[Docket No. 2001-SW-40-AD]

#### Airworthiness Directives; MD Helicopters, Inc. Model 369D, 369E, 369F, and 369FF Helicopters

**ACTION:** Notice of proposed rulemaking (NPRM).

**Figure 1 - Inspection Location**

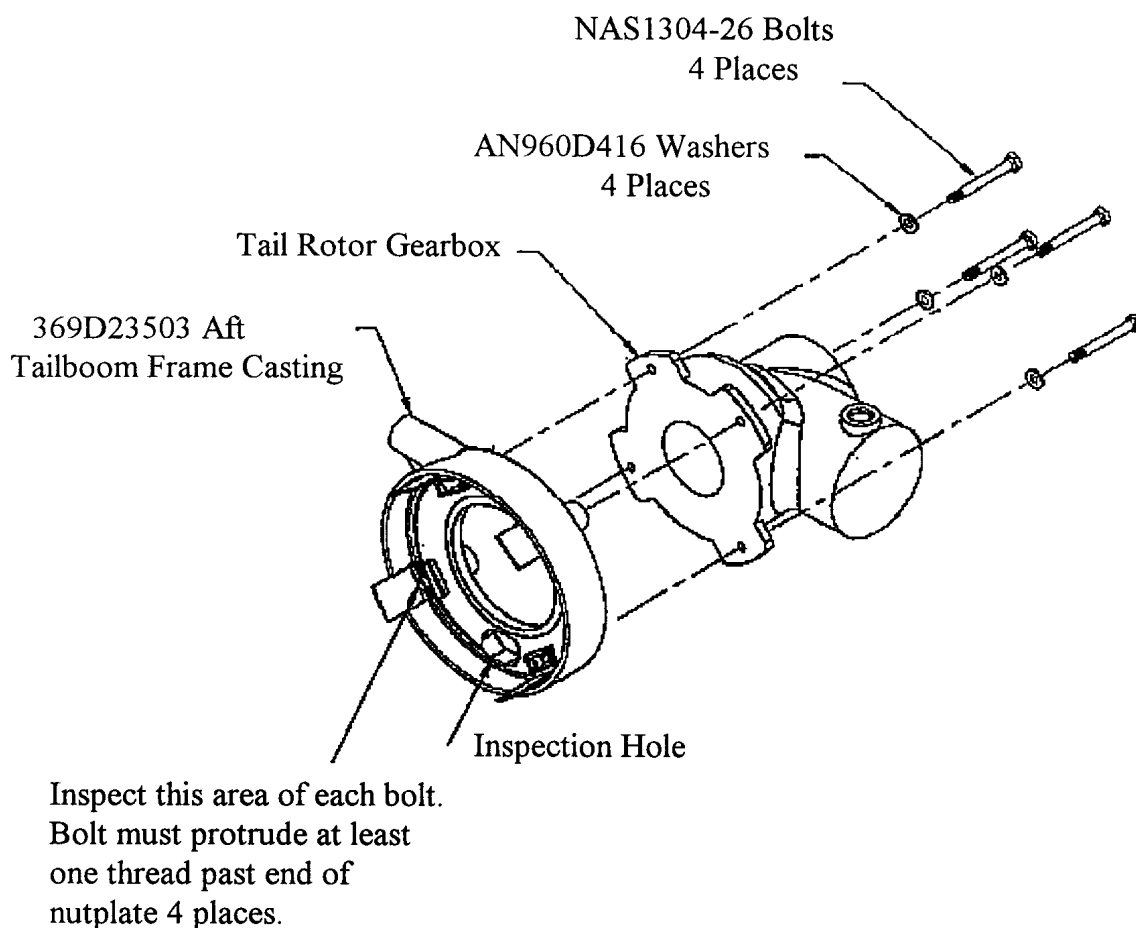
- (2) Remove the tailboom control rod and determine the number of bolt threads protruding from each nutplate on the internal surface of the aft tailboom frame casting, P/N 369D23503, as shown in Figure 1 of this AD. At least one thread must protrude. If more than four threads protrude, add an additional washer, P/N AN960D416, under the bolt head. Torque the bolt to 100–110 in-lbs, and reapply a slippage mark. See Figure 1:

(b) Between 2 and 10 hours TIS after accomplishing the requirements of paragraph (a) of this AD, inspect the torque on each bolt by applying 100 in-lbs. If any bolt movement occurs, retorque the bolt to 100–110 in-lbs. Reapply a slippage mark to the bolt regardless of the outcome of the torque test. Reinspect the torque between 2 and 10 hours TIS thereafter until no bolt movement occurs.
